Part 21 (PAR)

Event # 46923

POTENTIAL DEFECT IN CERTAIN VELAN SUPPLIED GLOBE VALVES

Subject: Globe Valve Notification, sizes 0.5, 0.75 and 1 NPS, Class 800, Carbon Steel

Exhibit # 1

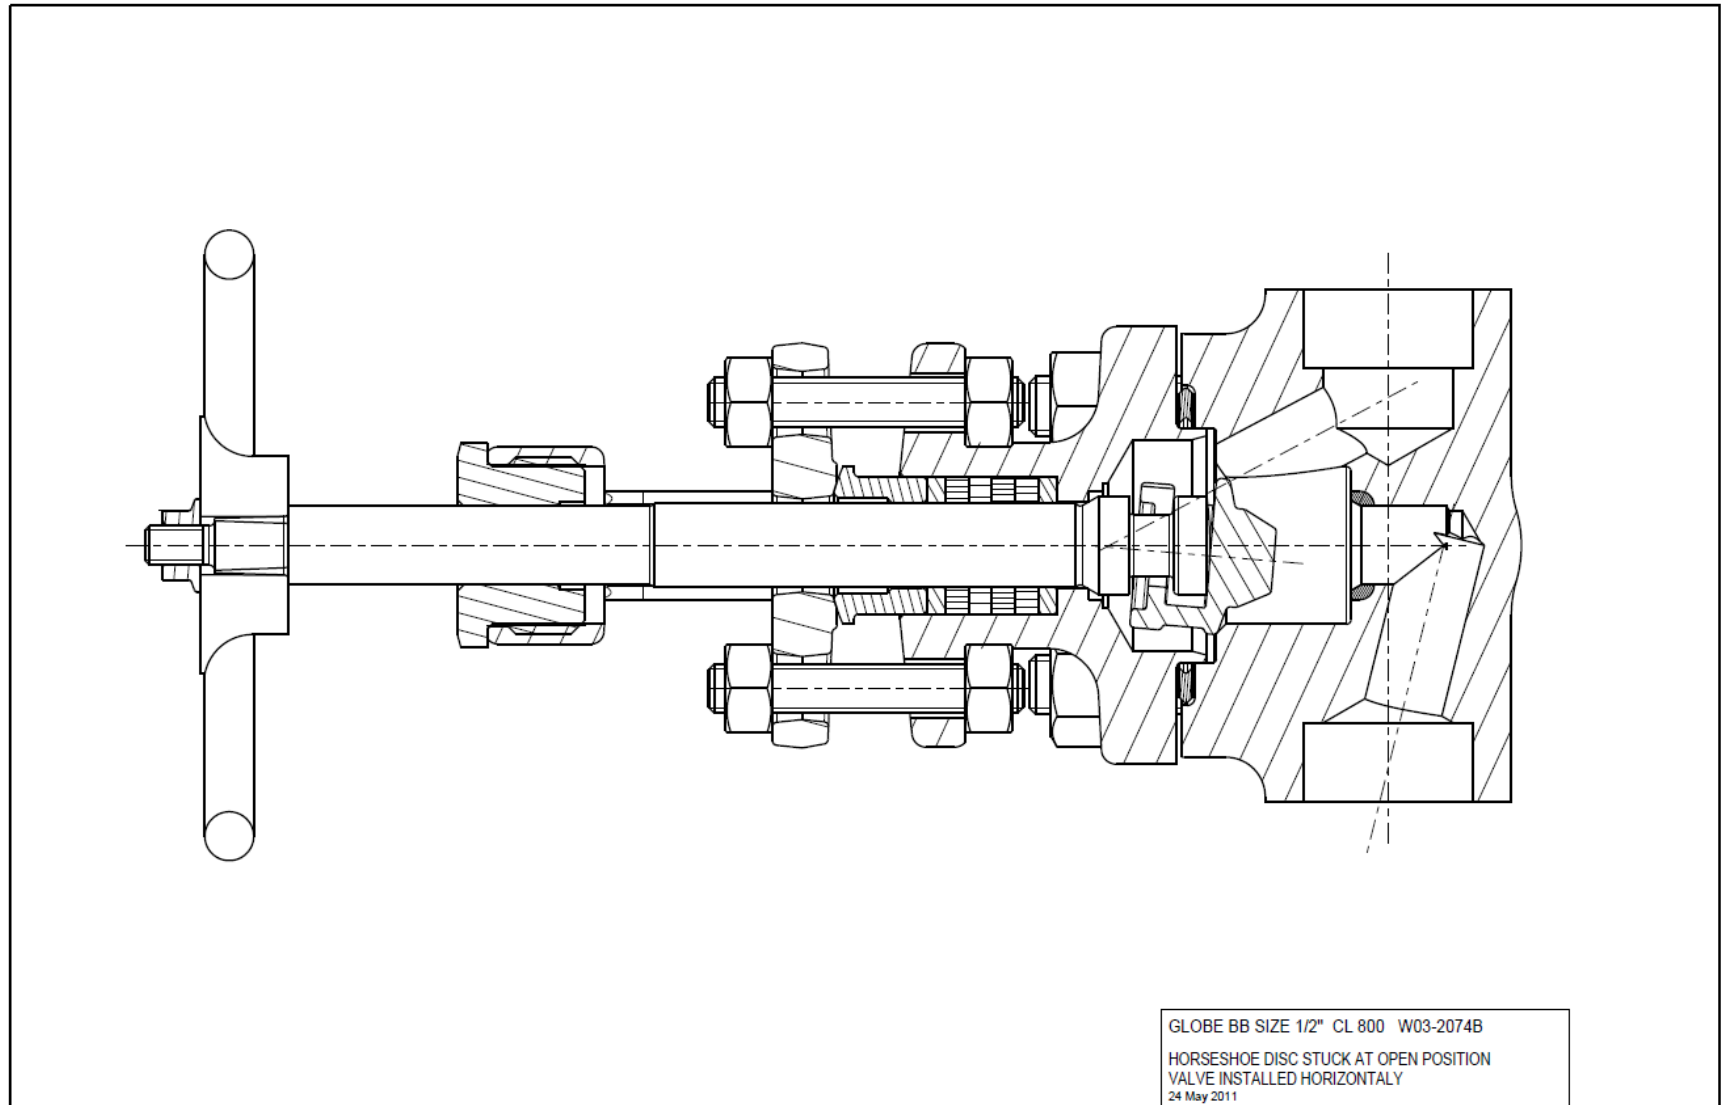
The valve was installed with the stem in a horizontal orientation; during the installation and commissioning procedure the valve was fully open (on the back seat position). The disc travelled into the bonnet cavity and became jammed between body and bonnet; the sketch in Exhibit # 1 shows the failure mode.

The analysis revealed that the failure was caused by the wrong bonnet being installed on the valve which ultimately allowed the disc to travel too far into the bonnet cavity and consequently the disc dropped into the body-bonnet gap. This prevented the valve from being closed during manual operation. The event is covered by Millstone 2 OE 33277.
